**NORTH PLANNING COMMITTEE**  
**SCHEDULE OF ADDITIONAL LETTERS**

**Date: 22<sup>nd</sup> March 2016**

Item No.	Application	Originator
8	15/05061/REM: South Of Hermitage Farm	Agent 17.03.16

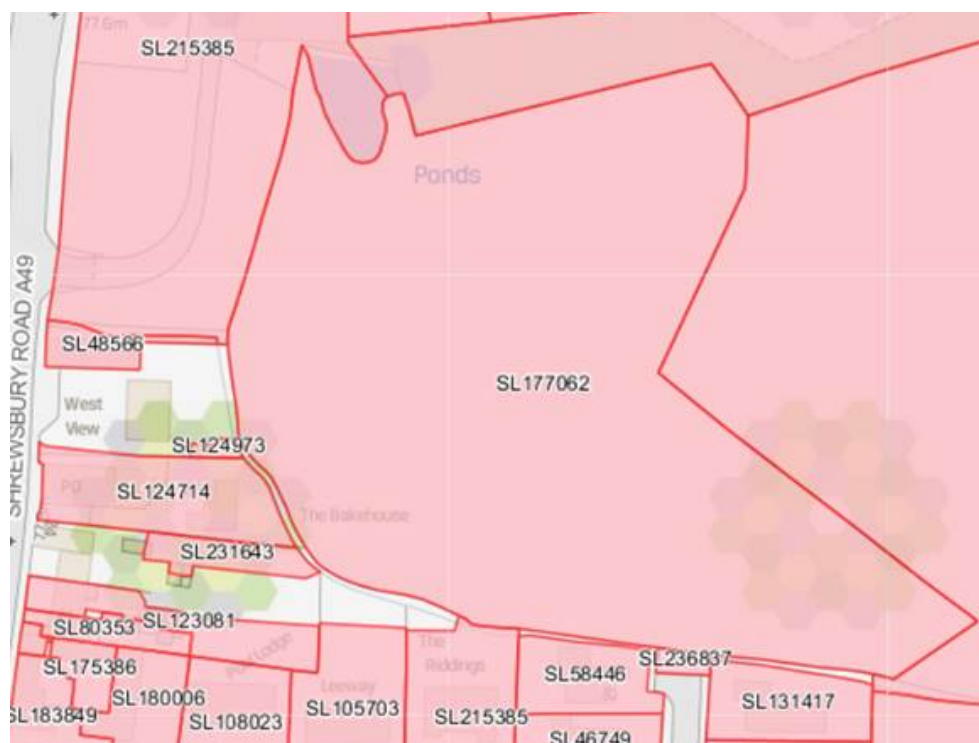
Please find attached the revised Landscape Proposals for this site. I also attach the GCN Mitigation Strategy which informed the revised landscape proposals, for information. I trust this will enable the Council's ecologist to support the scheme.
